PLANS OF PROPOSED MIDWAY DRIVE PICARDY AVENUE TO CONSTANTIN BLVD CITY PARISH PROJECT No. 20-CP-HC-0008

**SUMMARY OF ESTIMATED QUANTITIES**

**CHANGE ORDER AND/OR SPECIAL AGREEMENT**

SHEET NUMBER	34A
PARISH	EAST BATON ROUGE PARISH
CITY PROJECT	20-CP-HC-0008
STATE PROJECT	-
DESIGNED	NDP
CHECKED	AMR
DATE	7 OF 8
REVISION	DESCRIPTION
NO.	DATE
BY

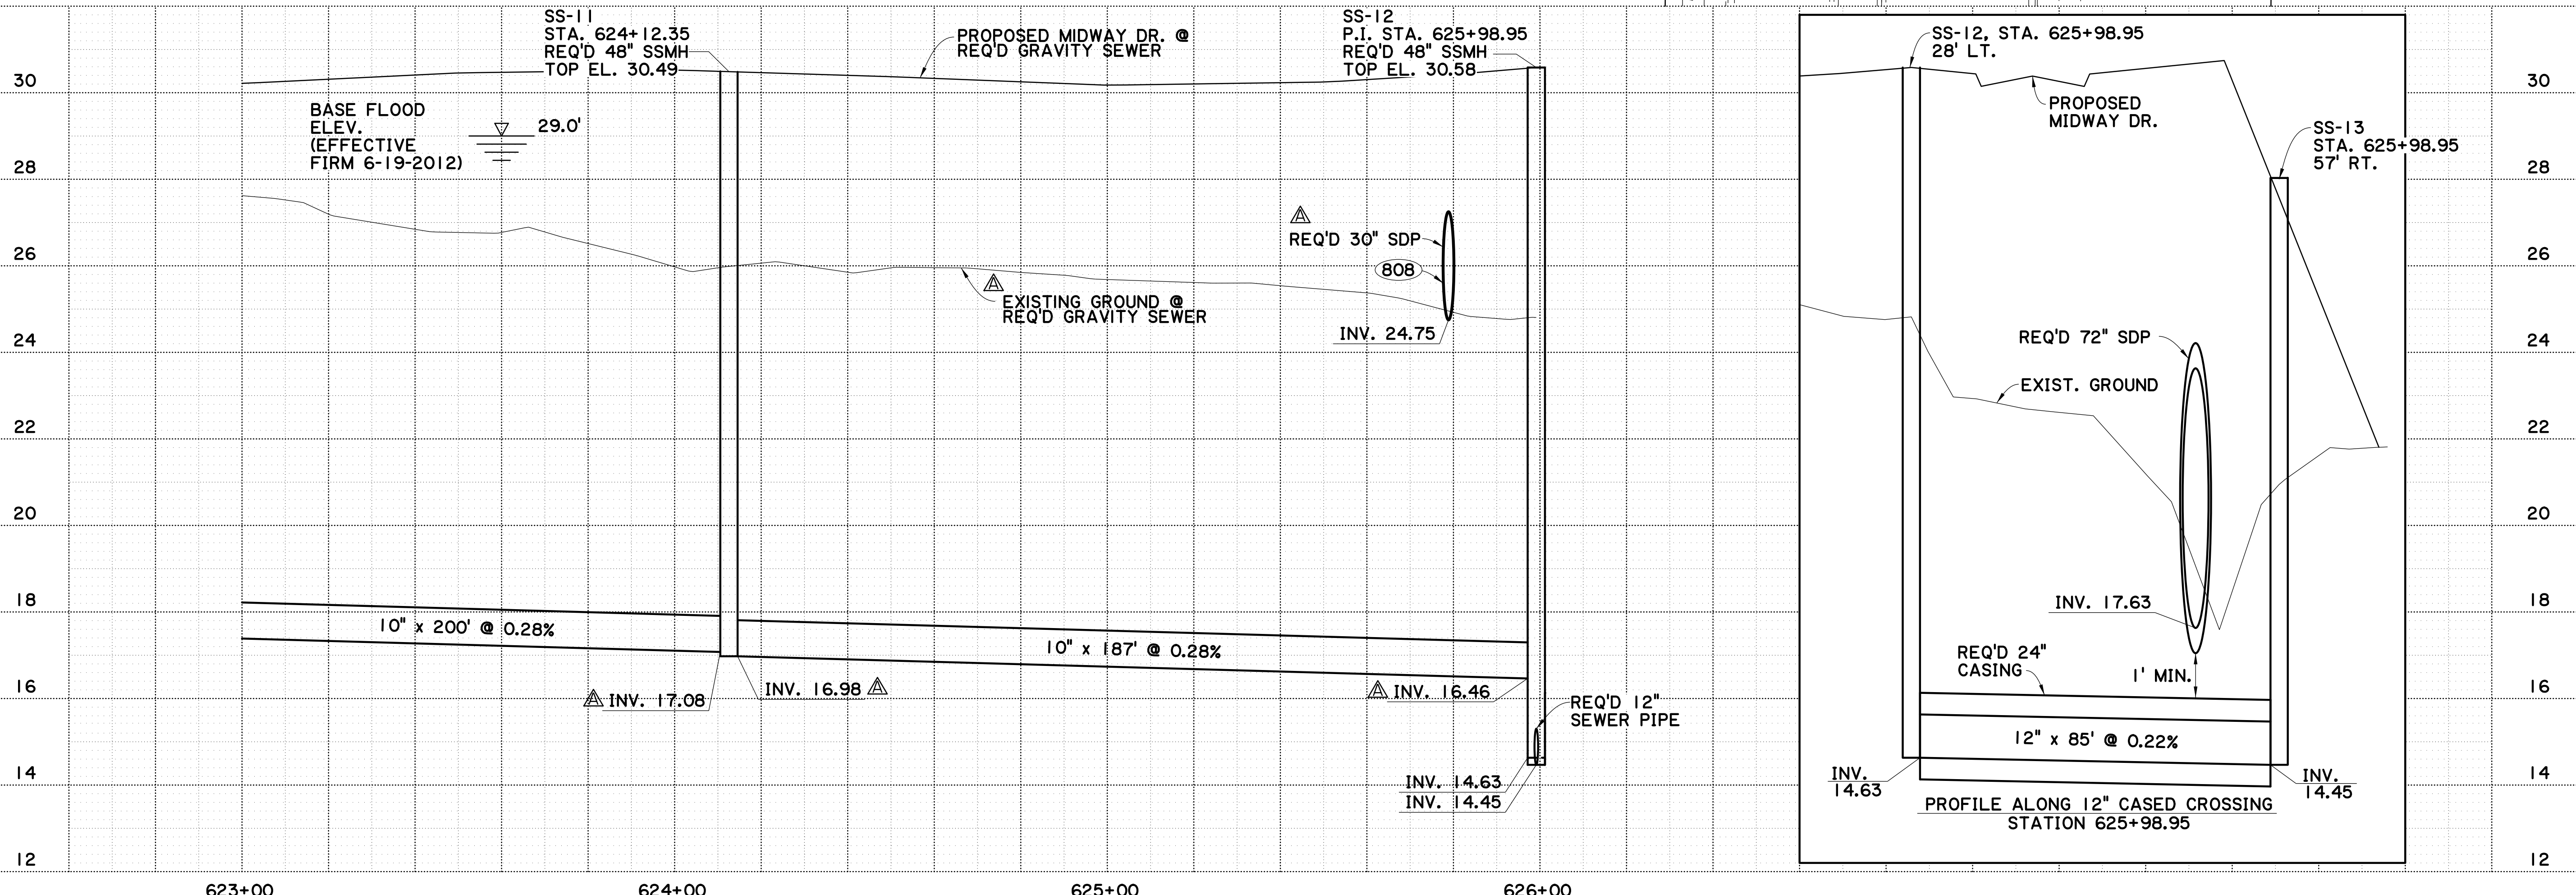
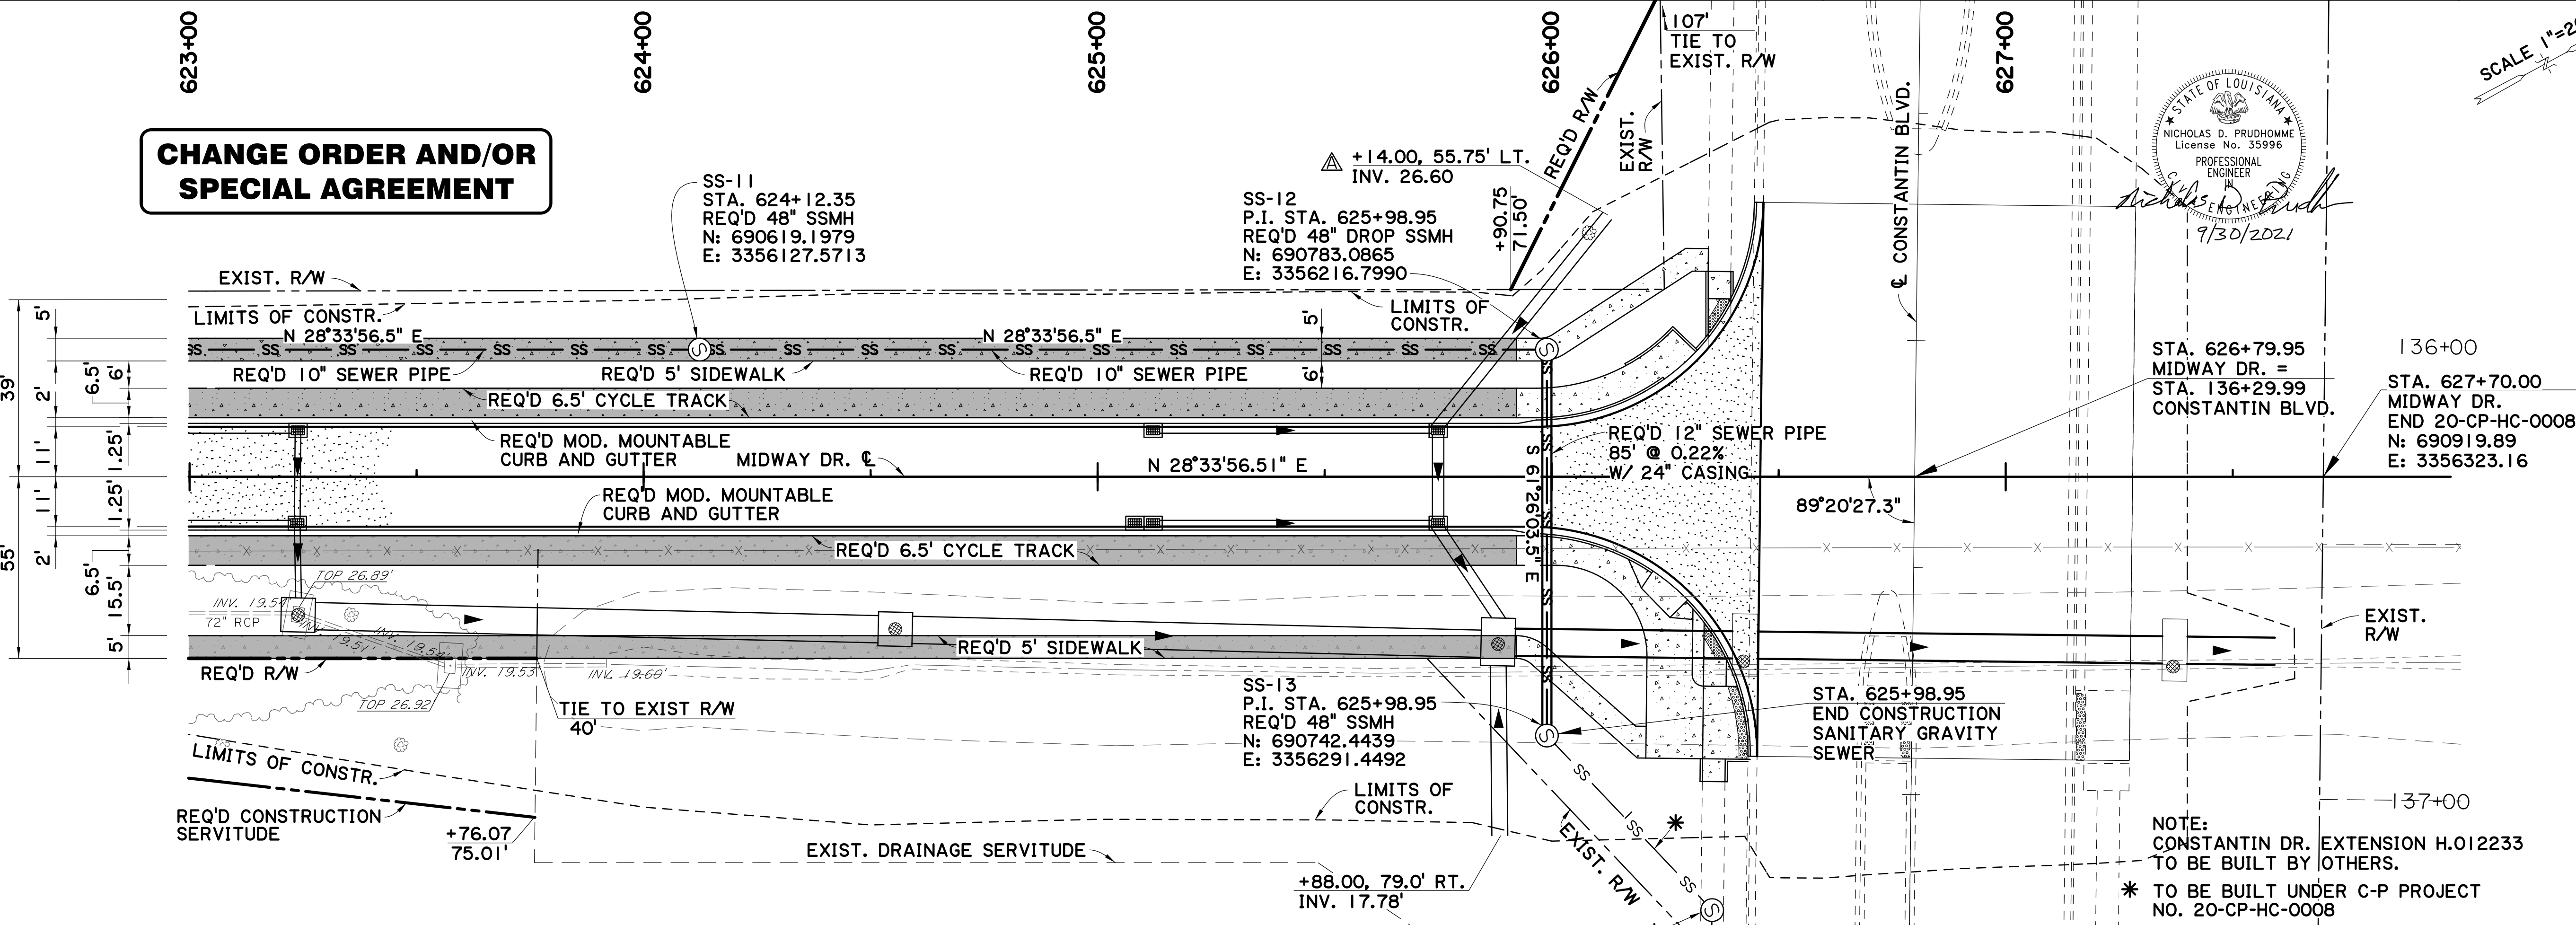
5-17-22 REVISED EXIST. PIPE SIZE, TYPE, & ELEV.; REVISIONS; UPDATED EXIST. GROUND LINE

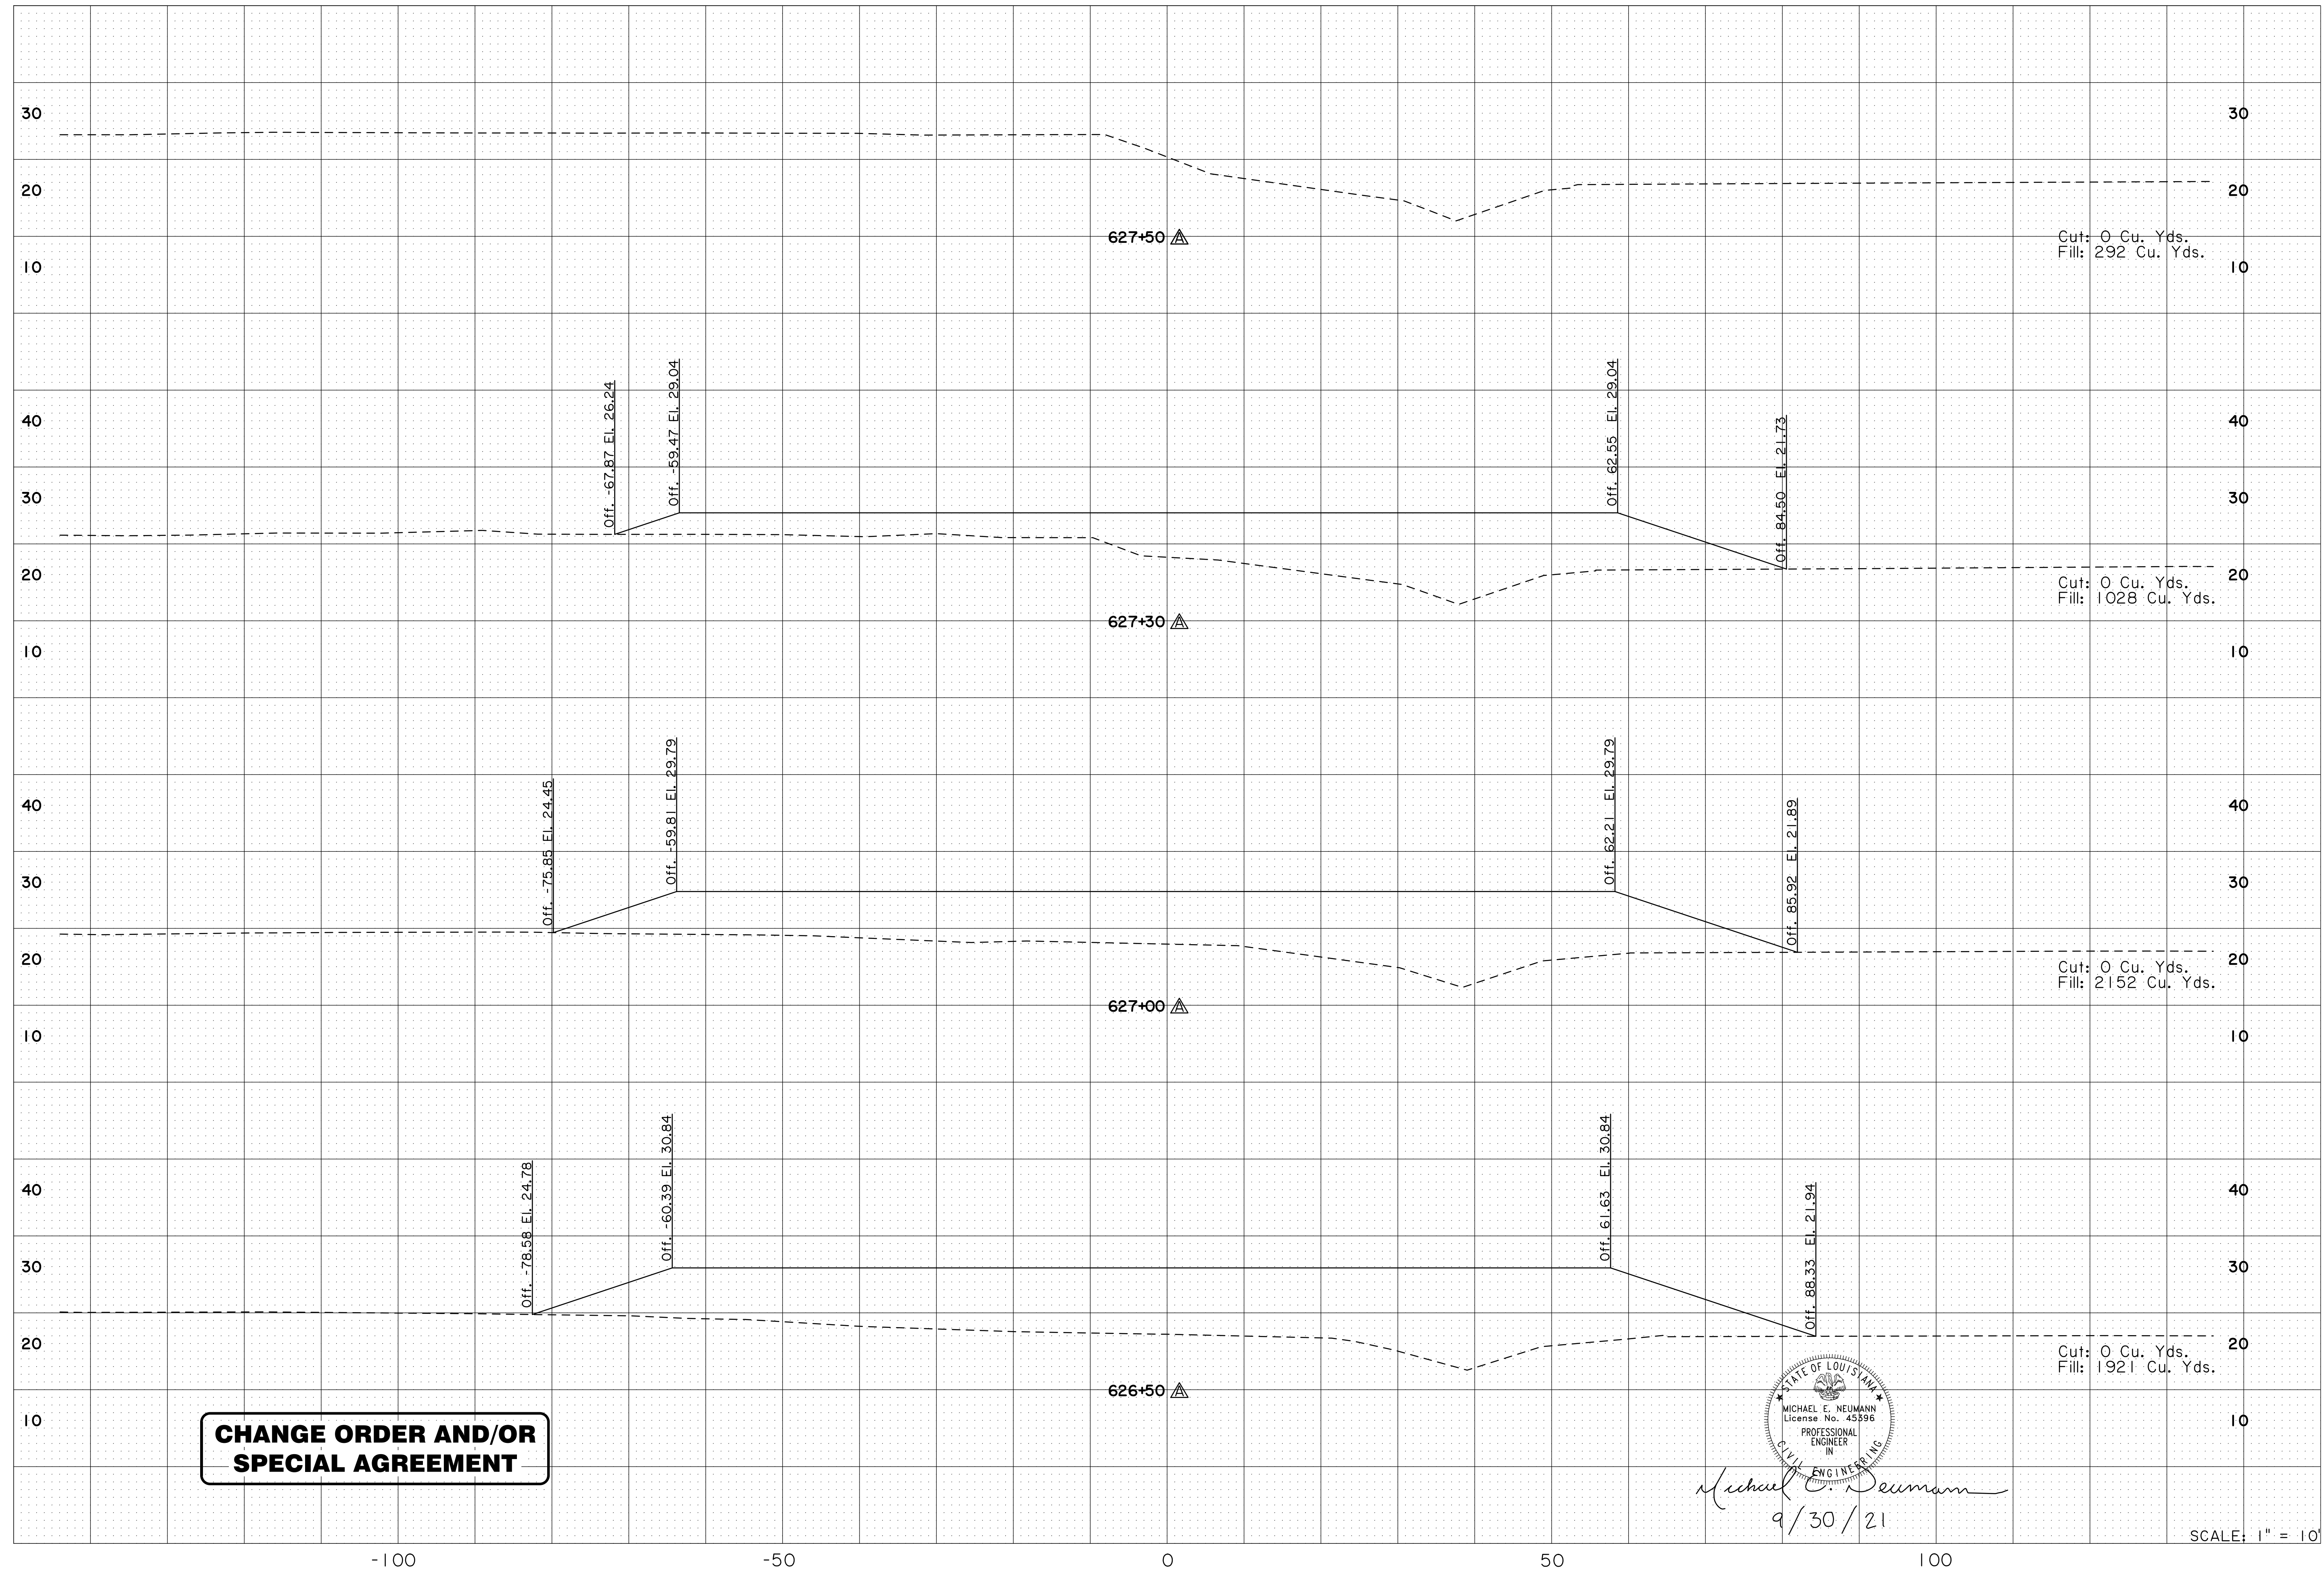
DESIGNED: MFB		EAST BATON ROUGE PARISH	
CHECKED: GDH		CITY PROJECT	
DESIGNED: MEN		20-CP-HC-0008	
CHECKED: MFB		STATE PROJECT	
DATE		10 OF 10	
5-17-22		-	
EXISTING SURFACE UPDATED FOR NEW SURVEY, BERM ADDED AT CONSTANTIN			
NO.		BY	
DATE		REVISION DESCRIPTION	
<b>CROSS SECTIONS (MIDWAY DR.)</b>			
MIDWAY DR. (PICARDY AVE. TO CONSTANTIN BLVD.)			
SHEET NUMBER		410A
